# Access Compliance Report

## Public Rights-of-Way

### (Curb Ramps)

Intersection ID: 42494	Main Street: BULLOCK GREENWAY BV	Cross Street: TOLLESON AV	Location: NE
ADA ID: FE0D16212D55	Ramp Type: PerpDiag	Initial Pass/Fail: Fail	Overall Compliance: No
Severity Score: 22.5			
Codes/Mitigation Info/Possible Solution		Field Measurements/Component Compliance

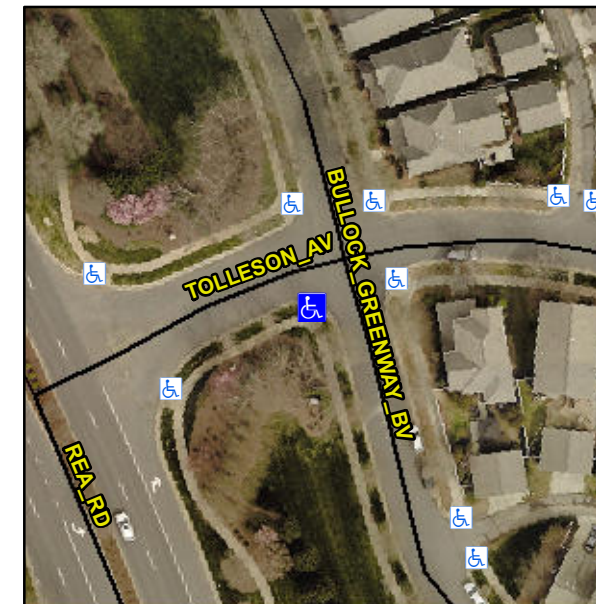
**Not Found, R304.5.1, R304.2.2, R304.5.3**

Compliance	Description	Data	Compliance	Description	Data
N/A	Ramp Length (in)	74.0	No	Ramp Slope (%)	8.6
No	Ramp Width (in)	43.0	No	Ramp XSlope (%)	2.5
N/A	Flare Type LT	N/A	N/A	Flare Type RT	N/A
N/A	Flare Slope LT (%)	N/A	N/A	Flare Slope RT (%)	N/A
N/A	Flare Traversable LT?	N/A	N/A	Flare Traversable RT?	N/A
N/A	Landing Length (in)	N/A	N/A	DWS Provided?	N/A
N/A	Landing Width (in)	N/A	N/A	DWS Contrast?	N/A
N/A	Landing Slope (%)	N/A	N/A	DWS Length (in)	N/A
N/A	Landing X Slope (%)	N/A	N/A	DWS Full Width?	N/A
N/A	Landing Curb? (Y/N)	N/A	N/A	DWS Offset (in)	N/A
N/A	Shared Landing?	N/A			
N/A	Gutter Ponding?	N/A	N/A	Gutter Slope (%)	N/A
N/A	Gutter Lip Ht (in)	N/A	N/A	Gutter X Slope (%)	N/A
N/A	Painted X Walk1?	No	N/A	Painted X Walk2?	No
	X Walk 1 Direction	To E		X Walk 2 Direction	To N
N/A	X Walk 1 Width (in)	N/A	N/A	X Walk 2 Width (in)	N/A
	X Walk 1 Slope (%)	1.3		X Walk 2 Slope (%)	2.1
	X Walk 1 X Slope (%)	0.8		X Walk 2 X Slope (%)	2.6

**Remove & Replace Curb Ramp With Two New Directional Ramps or Equivalent.**
